DPC-NE-2005-A

Duke Power Company Thermal-Hydraulic
Statistical Core Design Methodology

Request for Additional Information
Review of Duke Topical Report DPC-NE-2005P,
Appendix D, "Oconee Plant Specific Data, Mark-B11 Fuel,
and Application of BWU-Z CHF Correlation to Mark-B11
Mixing Vane Spacer Grid Fuel Design"
to DPC-NE-2005P, "Duke Power Company
Thermal-hydraulic Statistical Core Design Methodology"

Response to NRC Request for Additional Information
on Appendix D to Topical Report DPC-NE-2005-P,
"Duke Power Company Thermal-Hydraulic Statistical
Core Design Methodology"

Figure D-1 - Mark-B11 Vane Data
VIPRE-01 Measured Versus Predicted CHF

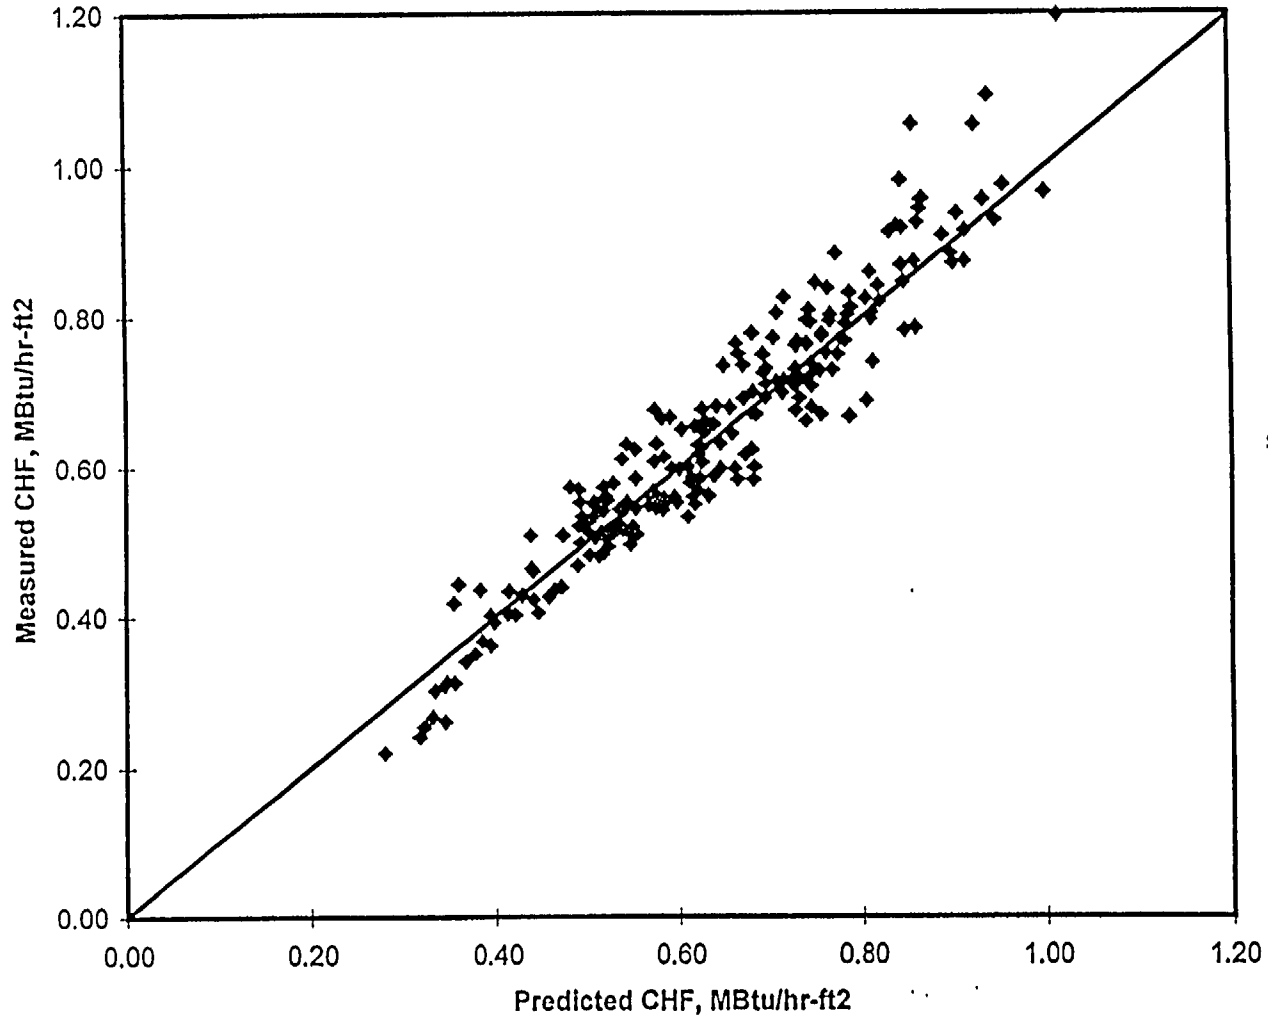
5. *The calculation with the VIPRE-01 code using BWU-Z correlation form for B11 fuel show essentially the same results as those obtained with LYNX over the correlation's database (as documented in Addendum 1 of BAW-10199). However, the BWU-Z correlation as modified for analysis of B11 fuel has not yet been approved by the staff, and the topical report describing this correlation, Addendum 1 of BAW-10199, is still being reviewed. This means that the design limit DNBR for the parameter ranges stated in Table D-2 may not be the final approved value or range of applicability. Specifically, the database for the form of the correlation spans a pressure range of 700 to 2400 psia, not 400 to 2465 psia range stated in Table D-2. Also, the plot in Figure D-3 (see p. D-11) shows a distinct nonconservative bias with decreasing pressure (which is identical to the trend shown for the correlation in the Addendum 1 submittal). There is also a nonconservative bias with the increasing power, clearly shown by plot of measured versus predicted Critical Heat Flux (CHF) in Figure D-1. What would be the effect on the thermal-hydraulic statistical core design analysis for Oconee if the DNBR design limit of the CHF correlation for B11 fuel were to be increased, or if the range of applicability of the correlation were to be limited to pressures of 700 to 2400 psia?*

The pressure range reported in Table D-2 is consistent with the conclusion made in Addendum 1 of BAW-10199. The Addendum 1 conclusion states that the correlation parameter range for the BWU-Z correlation with the Mark-B11V multiplier is the same as the BWU-Z correlation. The data base for the Mark-B11 fuel included a pressure range of 595 psia to 2425 psia as stated in Table E-7 of Addendum 1 to BAW-10199. Also, Figure D-3 shows a slight conservatism with decreasing pressure. Likewise, Figure D-1 shows a slight conservatism with increasing power.
